Re: **Archstone Communities**  
**April 2, 2002, Planning Commission Docket Items 5-A and 5-B**

ARCHSTONE – CAMERON STATION (PHASE VI)

DEVELOPMENT SPECIAL USE PERMIT #2000-0031

**Archstone-Cameron Station**  
**Exhibit List**

### **Plan Revisions from May 2001 to Current Plan**

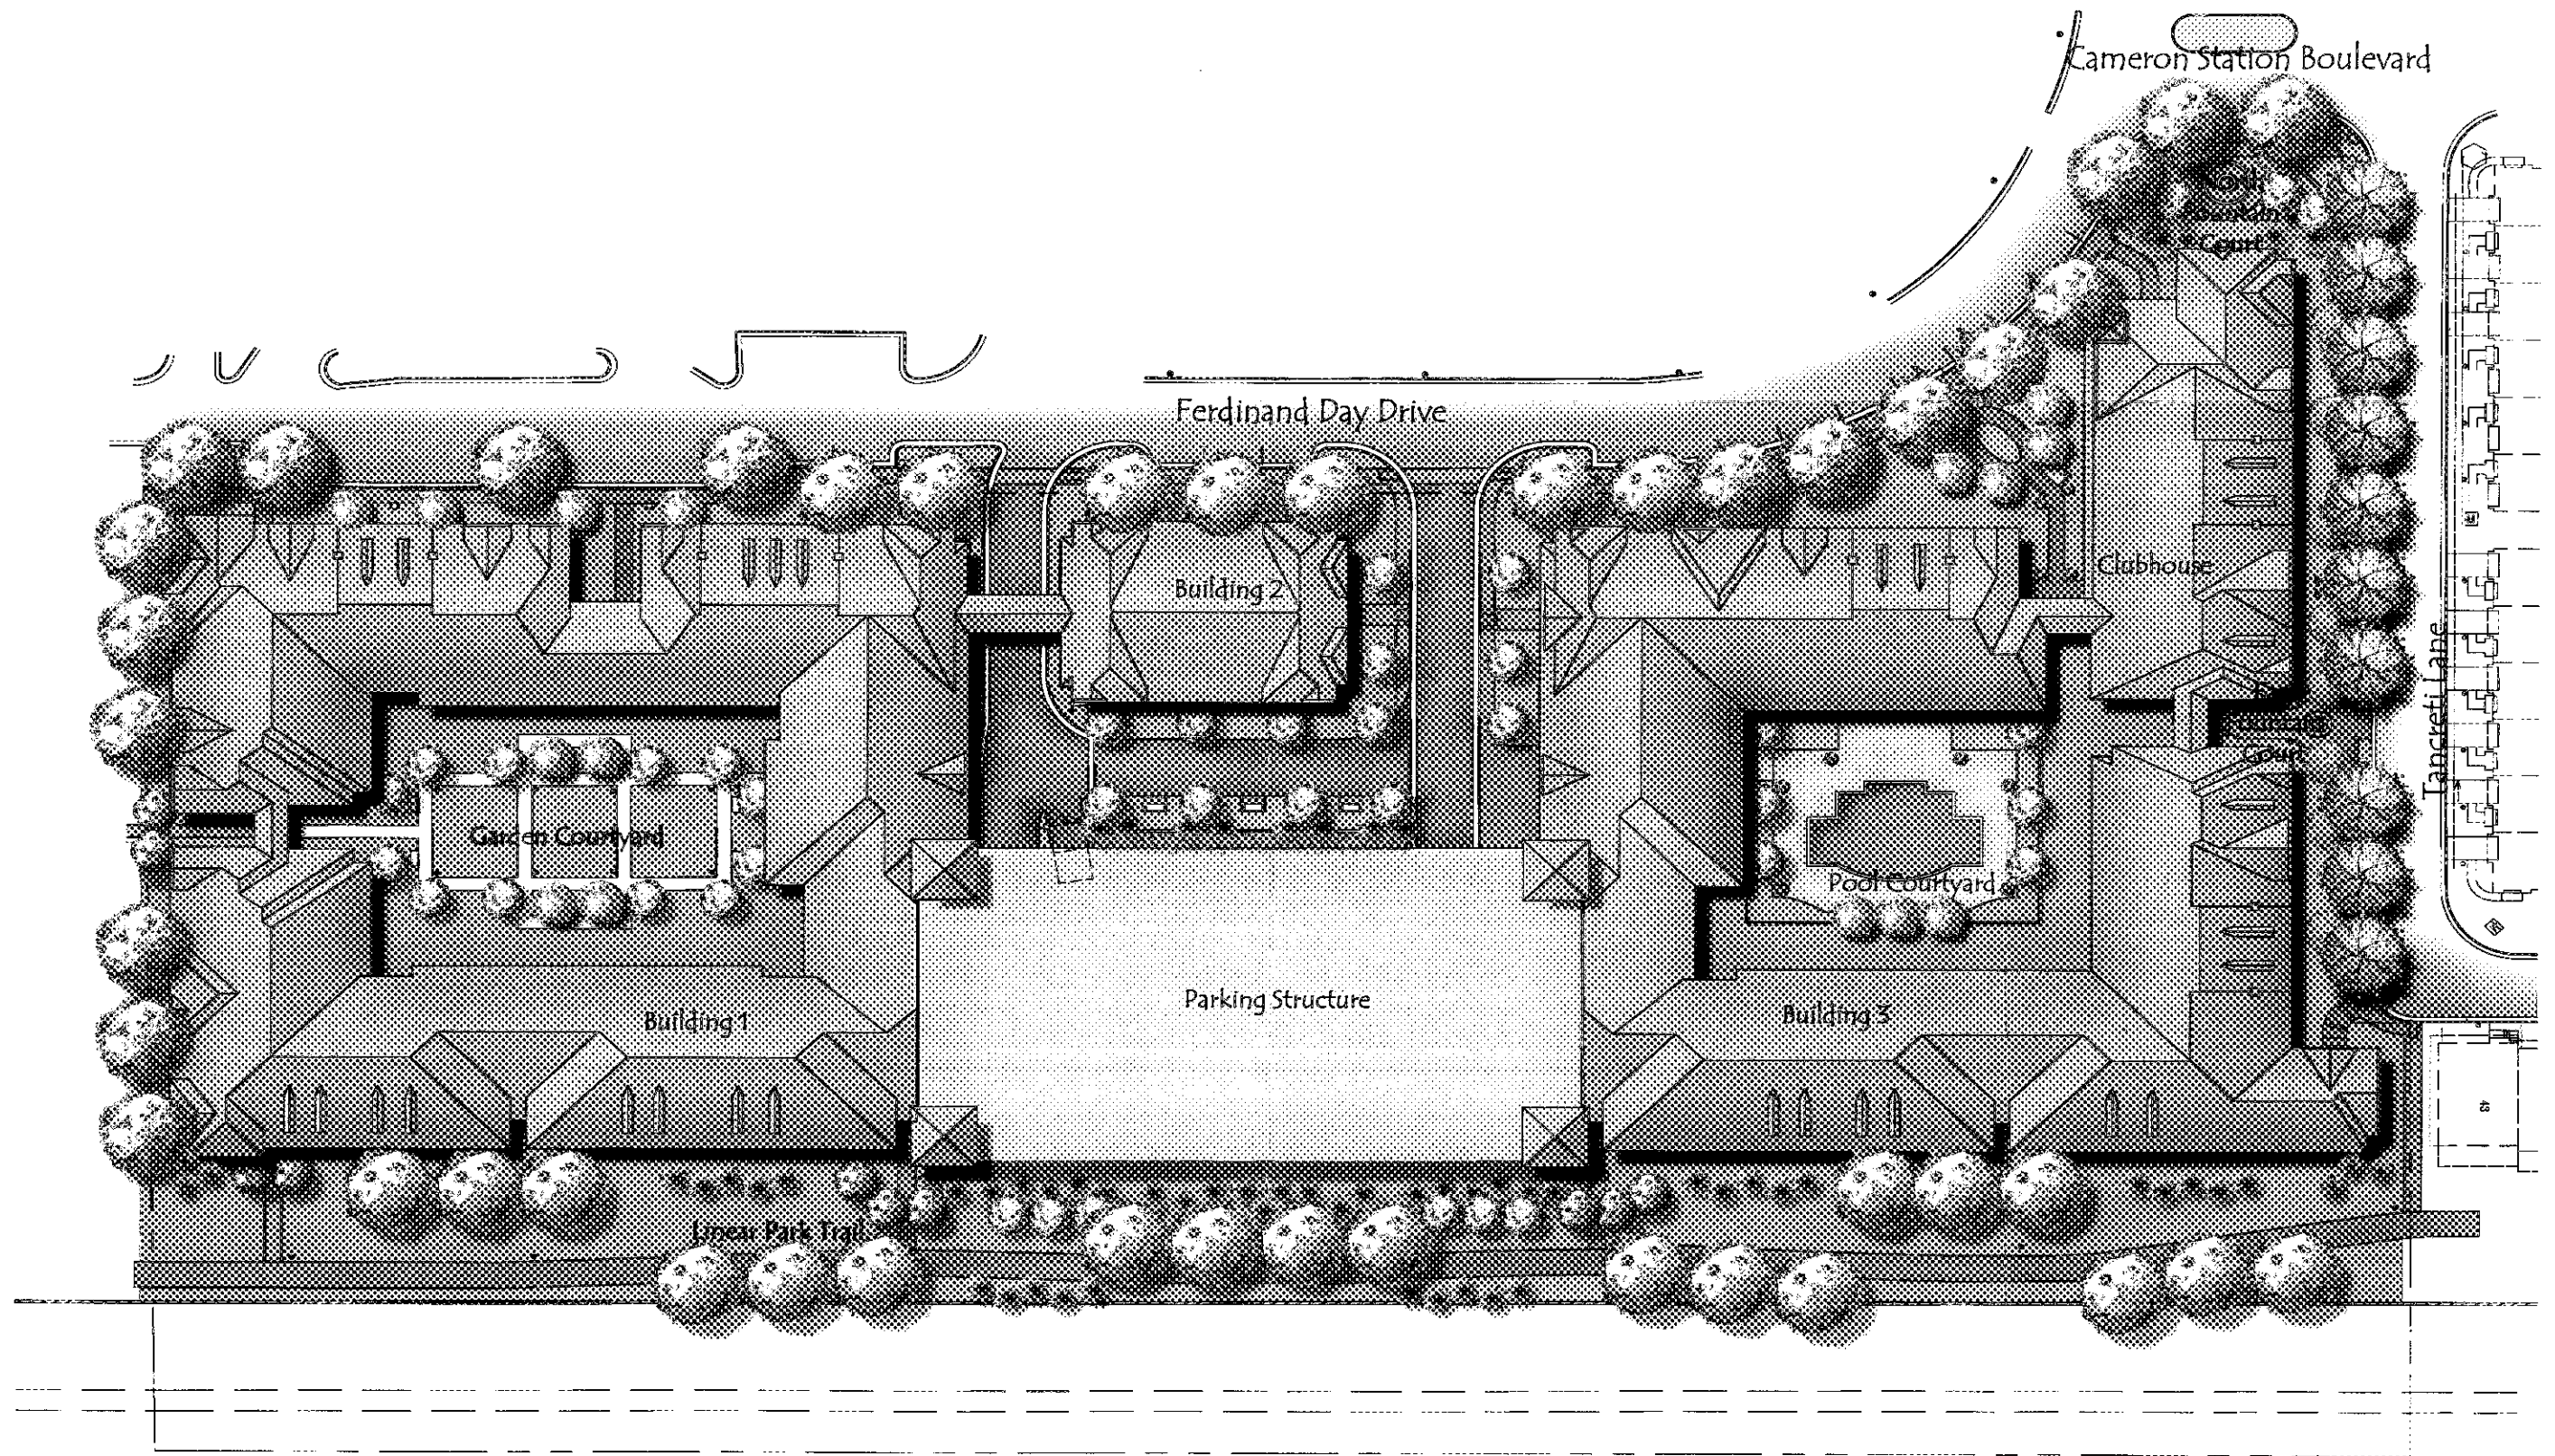
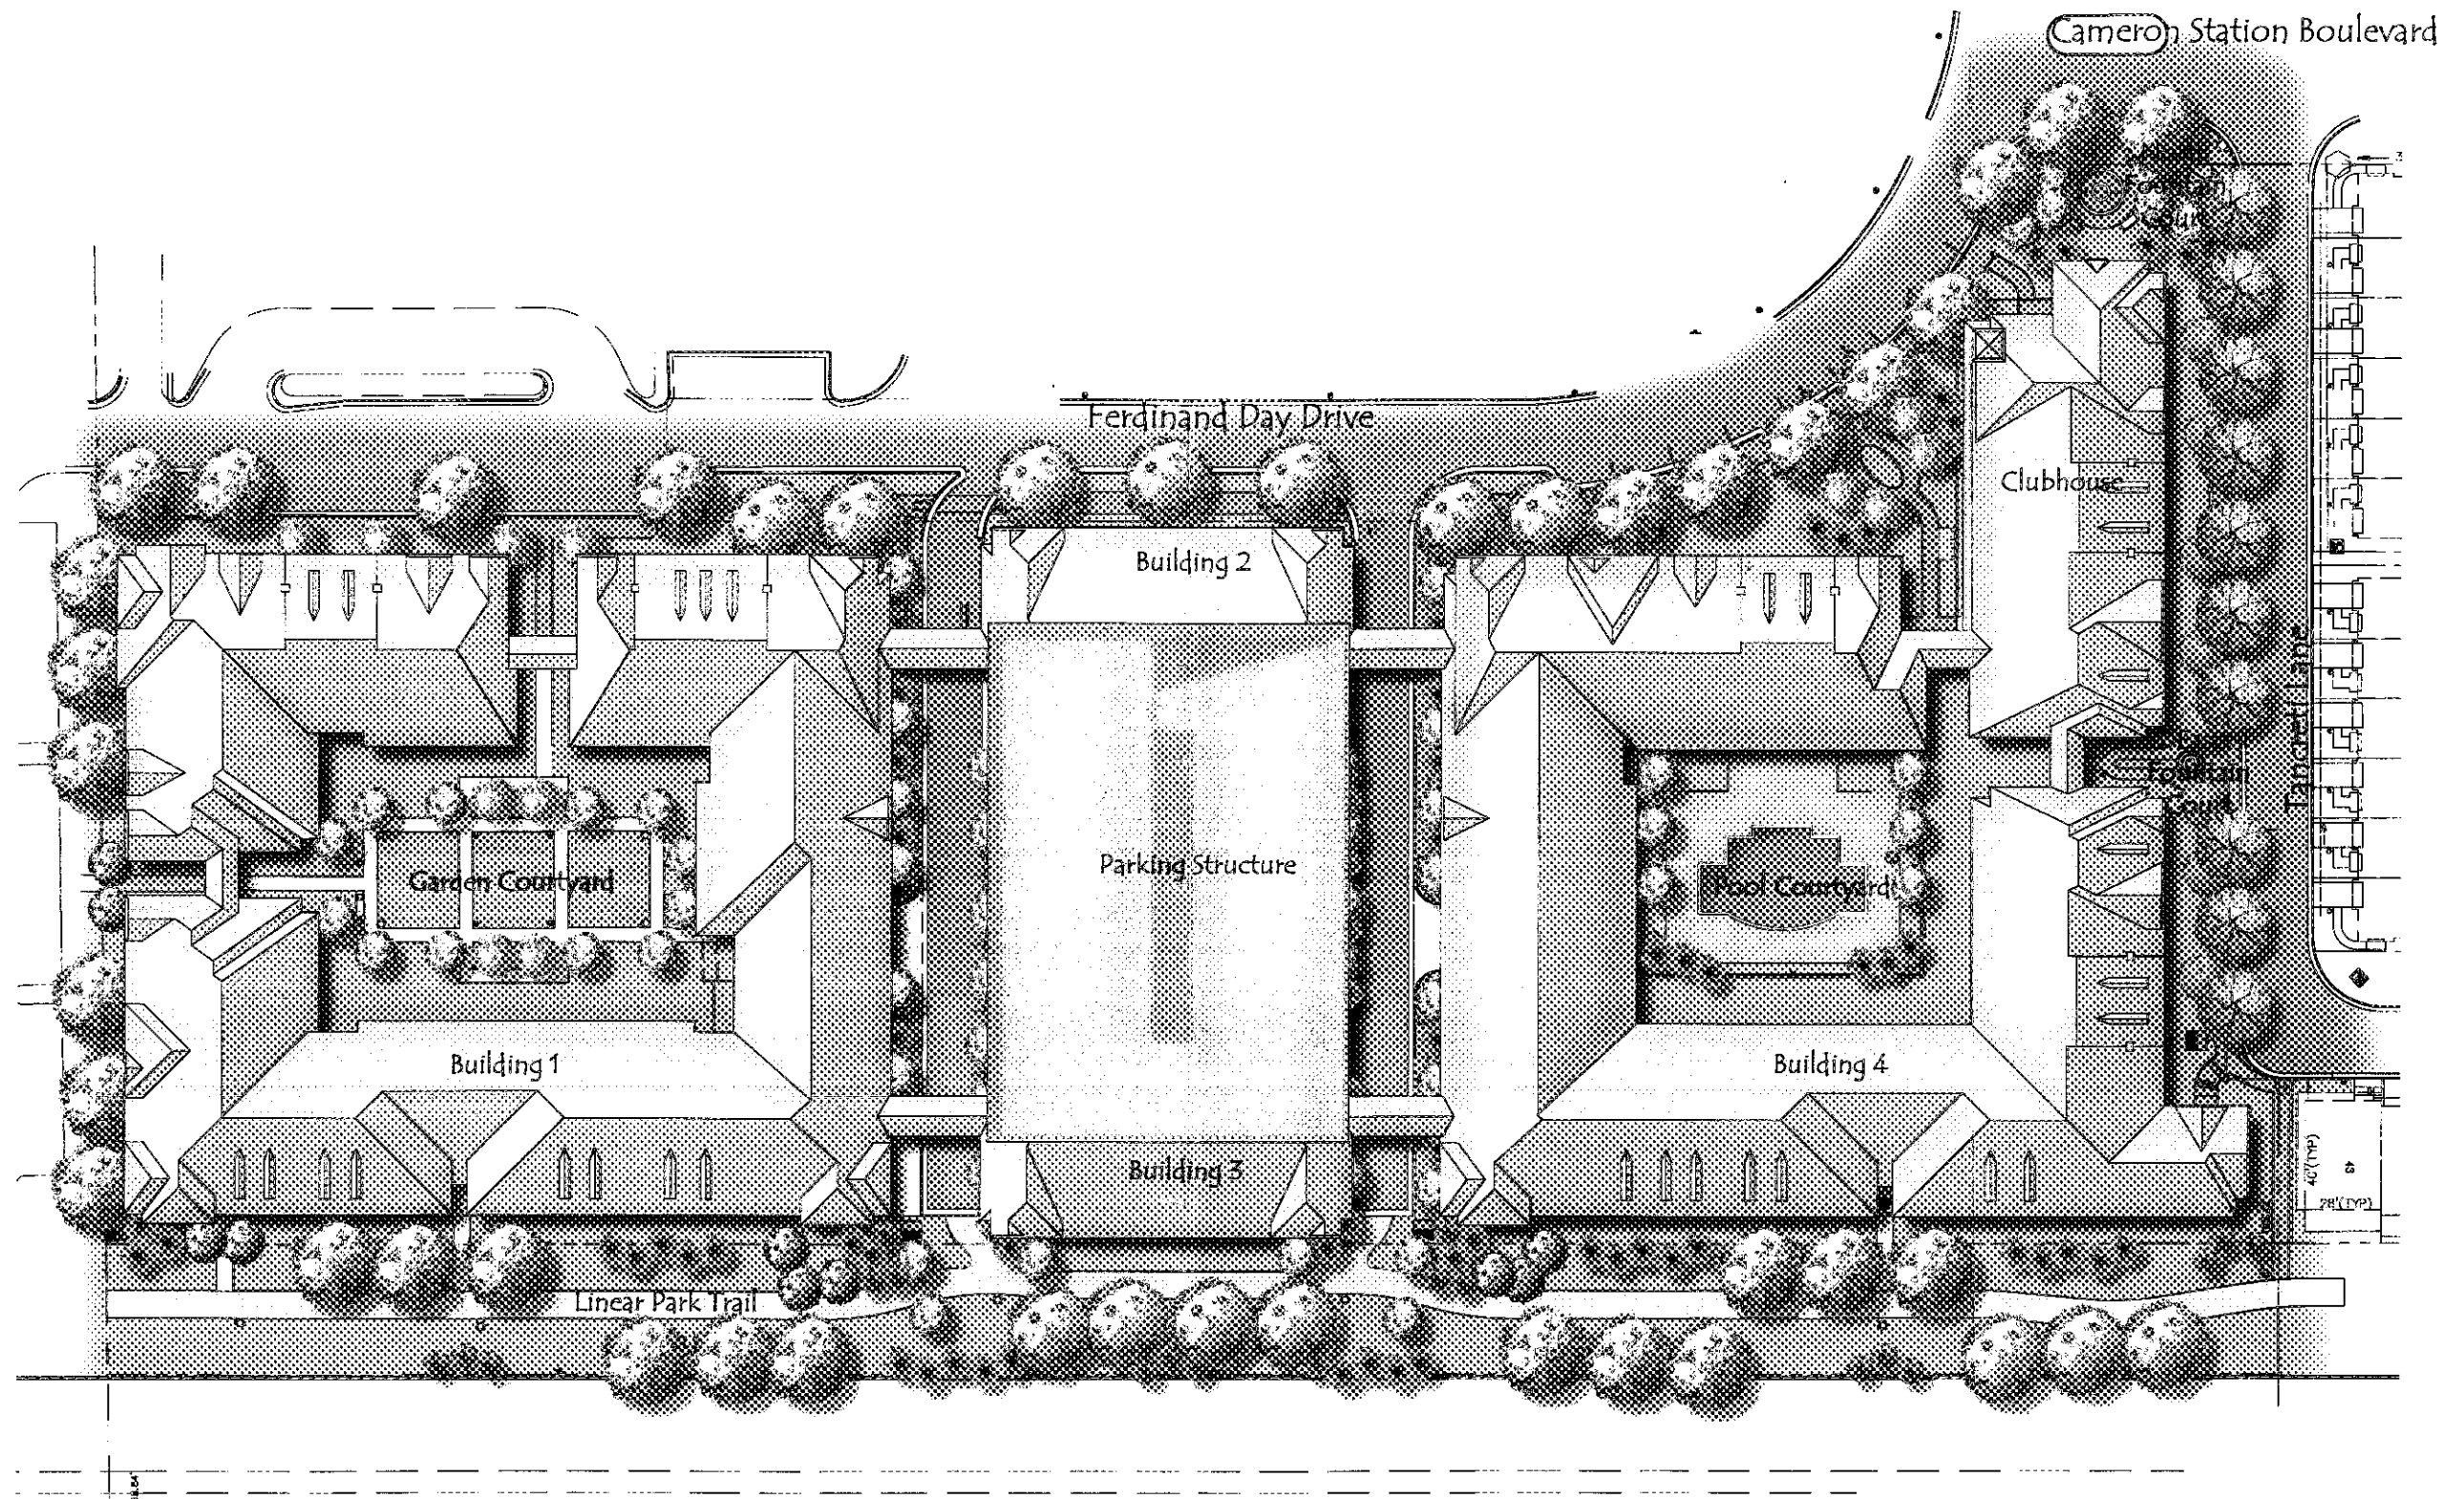
1. 90 degree reorientation of the parking structure, facing of the parking structure with units along Ferdinand Day Drive and the Linear Park, and architectural treatment of the parking structure along the drive aisles/EVEs.

2. Reduction in the size of the parking structure from 236' x 122' to 184' x 123', which represents a 6,160 square foot reduction in the parking structure footprint and a reduction of 36,960 square feet of parking structure mass.

NORTH ELEVATION WITH BUILDING BREAKS

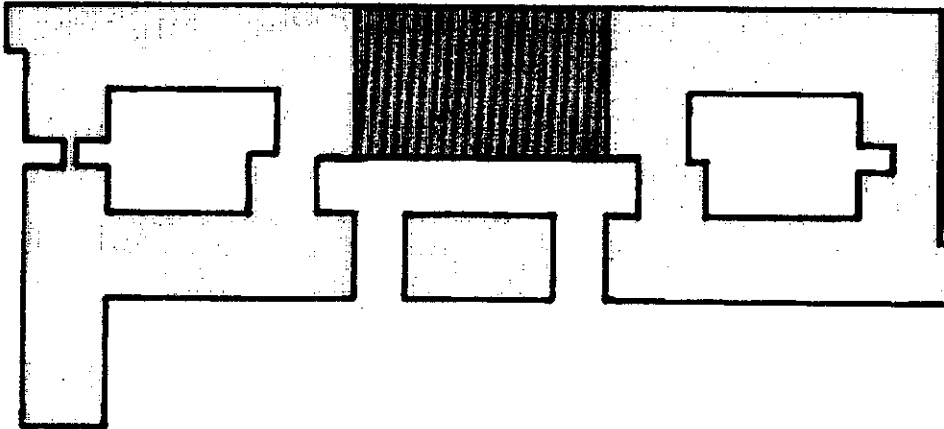
Clearly the building footprints exceed any precedent established within Cameron Station including the Main Street Condominiums. In fact, the 700 ft. of uninterrupted building on the southern portion of the building is more than double the length of any residential building footprint in Cameron Station. To provide building forms that are more consistent and compatible with the Cameron Station, staff is recommending several additional breaks within the buildings as depicted below:

SITE PLAN WITH BUILDING BREAKS

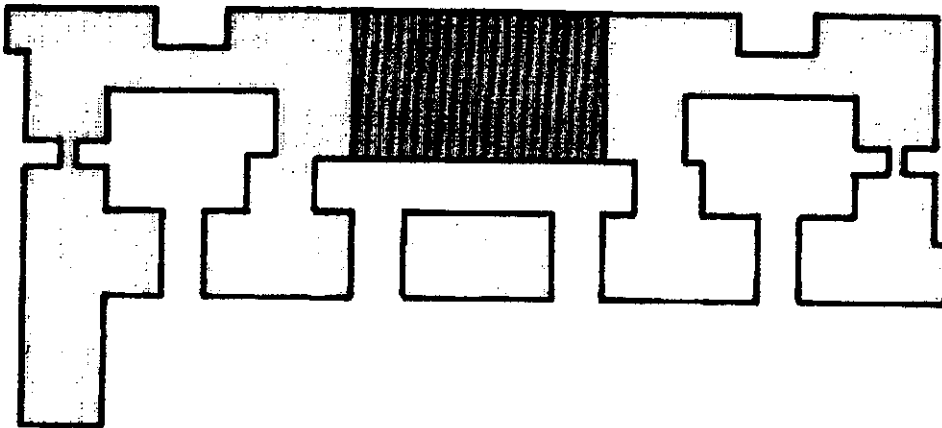
The additional building breaks or separation between the buildings will provide numerous benefits to the current design and site plan that include:

PARKING GARAGE WITH LOWER HEIGHT

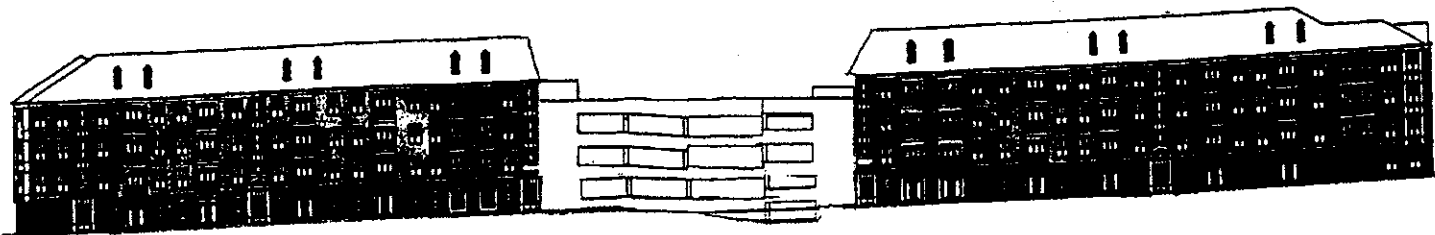
PARKING GARAGE (ADJACENT TO LINEAR PARK)
